Staff Responses to Questions Raised by Citizens Regarding Extension of Rosslyn Gateway Final Site Plan and Vacations

1/23/2017

The Phase 1 final site plan and vacations of the existing slip road for the Rosslyn Gateway Project (SP #419) were approved by the County Board on July 21, 2012 for a five year term. In anticipation of the expirations next summer, the applicant, JBG, is requesting extension for an additional three years.

Figure 1: Rosslyn Sector Plan Recommended Build-to Lines

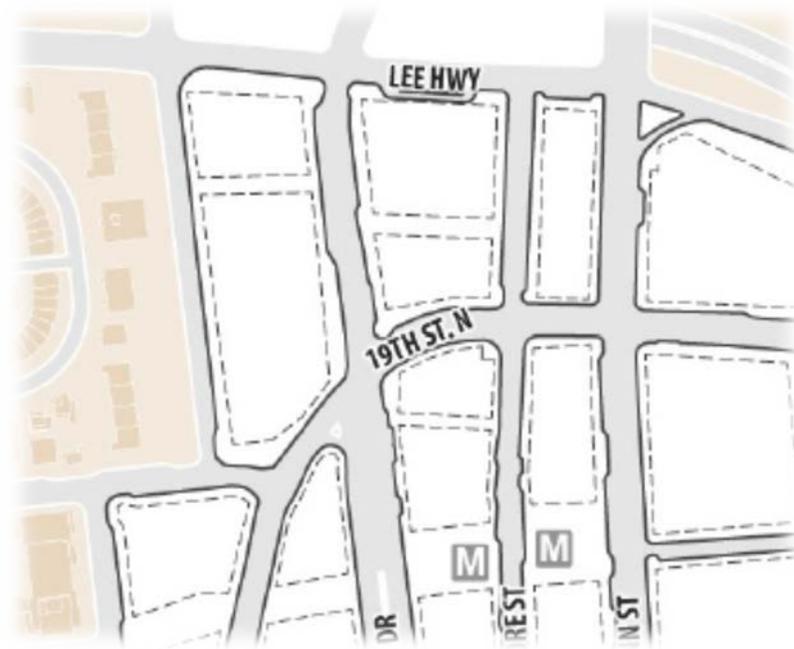
- Page 39 of the Plan calls for "expanding Rosslyn's tree canopy from approximately 5% to at least 15%." Using the space provided by a vacated slip road to expand the building's footprint is inconsistent with expanding tree canopy.

- Page 42 of the Plan calls for "reclaiming excess roadway area for expanded sidewalks, landscape, bike facilities." Using the space provided by the vacated slip road to expand a building's footprint is in flagrant violation of this provision.

(Staff response: Consistent with the 1992 Plan and 2011 Multimodal Transportation Study, the approved Rosslyn Gateway project eliminates the loop road and repurposes that space as part of its building envelope. In doing so, enhanced streetscapes will be provided with the provision of street trees consistent with County standards.)

(Staff response: This statement was provided as an opportunity for helping to enhance the walking environment, which currently faces many challenges. However, the sentence that follows that passages from the plan also states: "Renovate/redevelop aging buildings with edges that engage adjacent sidewalks, parks and plazas – which is something that the 2012 Rosslyn Gateway approval achieves.)
